THE BEAU HASSIN-PORT LOUIS LINK ROAD

MINUTES OF PROCEEDINGS

Topic: Beau Bassin - Port Louis Link Road Project

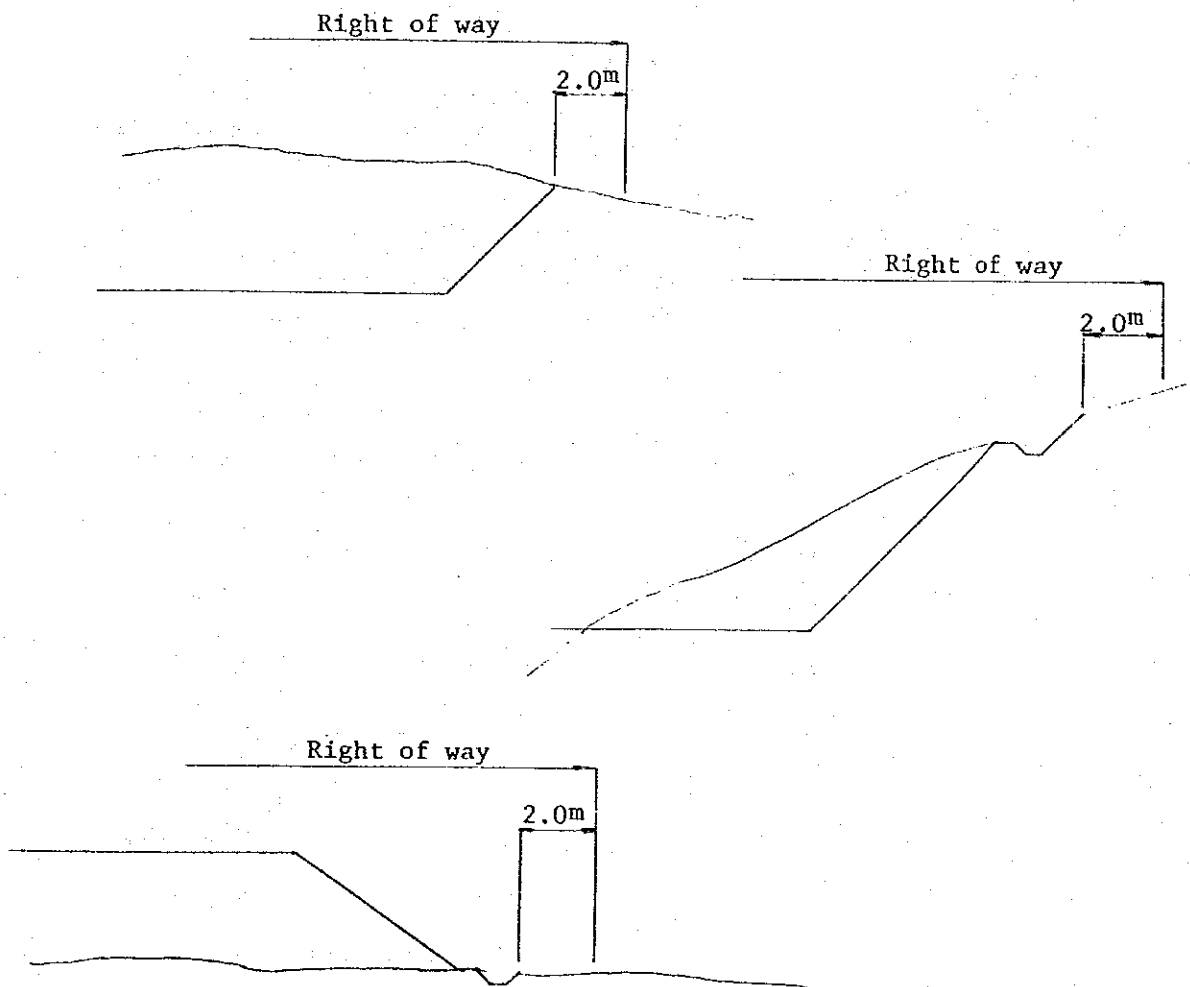
3. Stage construction of Motorway Junction is agreed on by each other as follows.

First Stage: (a) Construction of Roundabout

(b) Improvement of existing Motorway, which is undercrossing the roundabout.

Second Stage: Construction of the through road connecting the Port Louis Ring Road during the construction of the Ring Road.
